REQUEST

(ST1905) Mister Car Wash, 325 Baldwin, is requesting site plan approval to construct a 15x 23.5 foot canopy over two 3.5 by 8.5 foot concrete islands to be used as a pay station. In addition, the proposal is to reconstruct the vacuum area and create nine 20 by 13 foot stalls. This is in a (CS) Community Service Commercial district. P.P. # 70-14-13-200-008.

ID number	ST1905	Date 3/25/19 2 nd review	
Name	Mr. Car Wash		
Address	325 Baldwin		
Use	Pay station/vacuum area	SUP required	No. Allowed with Sec. 15.2(C)

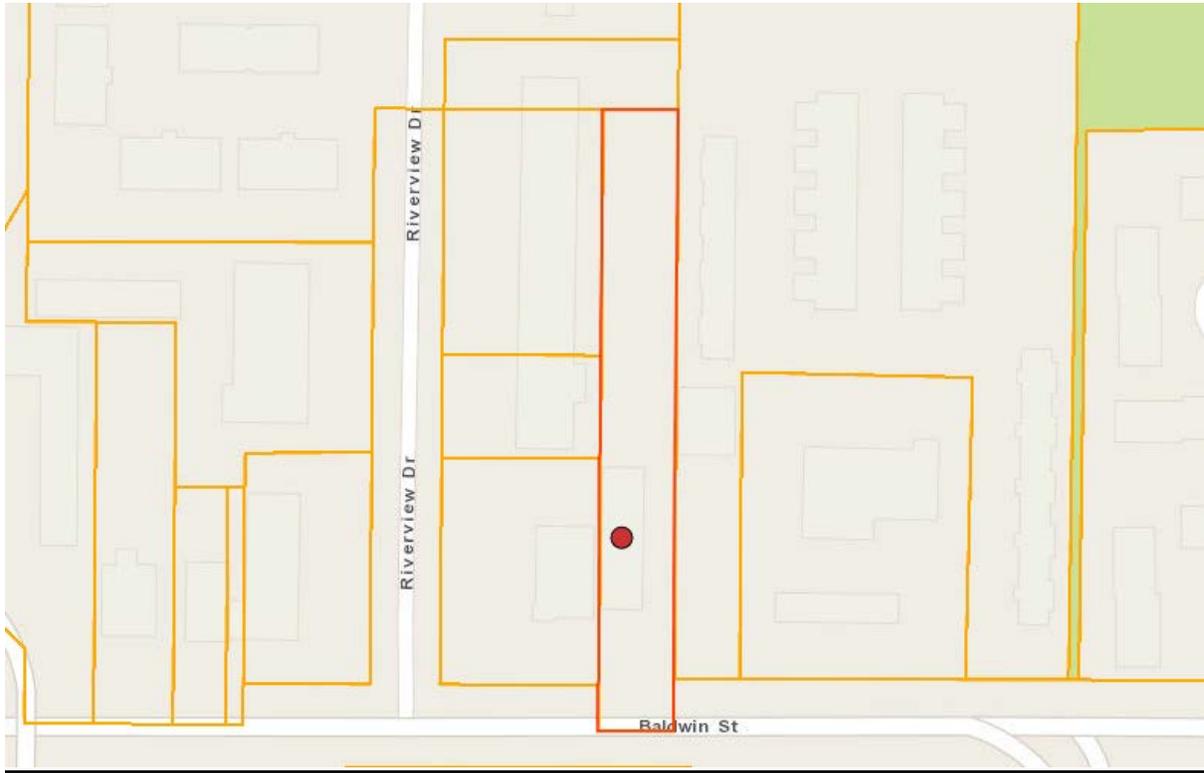
- a. Setbacks are required as follows. Note that some elements are nonconforming.
- Front on Baldwin 90 feet from the centerline of Baldwin (60 + 30 = 90). Footnote (m) applies and states that the first 30 feet shall be landscaped and not used for parking or drives. Streetscape/landscaping is provided.

- Side Zero on the west side and 25 feet plus greenbelt on the east side. **Evergreen trees were provided (minimum 5 feet tall) for every 20 feet or fraction thereof along the east property line, excluding where there is no parking.**

- Rear 40 feet. **No dimensions are shown from the building to the rear lot line.**
- b. Landscaping meets ordinance requirements for the streetscape (71/25 = 3 trees). **A greenbelt was provided for the areas of the parking and not required adjacent to the commercial area.**

- c. **A Storm Water Drain permit (written approval from the Water Resources-Drain Commissioner's Office) is required to be submitted at the time a building permit application is submitted.**

- d. **A DEQ permit is required to be submitted at the time a building permit application is submitted.**

- 1. A Storm Water Drain Permit (written permission from the Drain Commissioner's office) is necessary and will be required to be submitted to the Township at the time a building permit application is submitted.**
- 2. A DEQ permit is required to be submitted at the time a building permit application is submitted.**
